NACELLE - ELECTRICAL POWER - SUPPORT BRACKET, IDG POWER CABLE - REWORK OF - CATEGORY 6. ACCOMPLISH WHEN THE NACELLE SUBASSEMBLY (I.E. ACCESSORIES, COMPONENTS) IS DISASSEMBLED SUFFICIENTLY TO AFFORD ACCESS TO THE AFFECTED PART AND TO ALL AFFECTED SPARE PARTS. - MOD.NAC-24-0003

V2500-NAC-24-0003

Rework of I.D.G. Cable Support Bracket
Fig.1

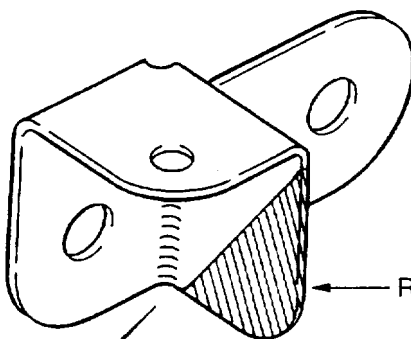
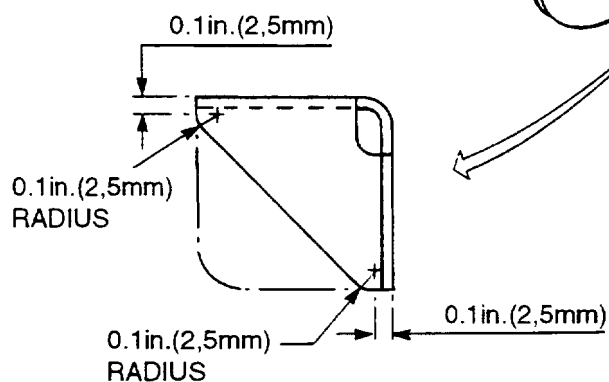
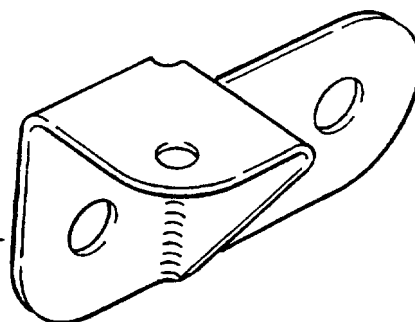
Relocation of a fan case bolt caused contact with a support bracket for the IDG power cables.

To ensure adequate clearance is maintained between the fan case bolt and the IDG power cable support bracket.

- (a) The existing bracket is modified to the new configuration by trimming one corner. These rework instructions are provided for spares stock (See Figure 1).

- (1) Cut off a corner piece from the 740-5965-501 bracket shown as a hatched area (Refer to Figure 1).
- (2) Use a file to shape the radii 0.1 inch (2.5 mm). Remove any burrs.
- (3) Reidentify the bracket to new part number 740-5965-503 with a vibro-etch engraver. Refer to the IAE/V2500 Standard Practices/ Processes Manual, Chapter 70-09-00.

REMOVE HATCHED AREA

REWORK DETAILS

RE-IDENTIFY BRACKET
740-5965-503
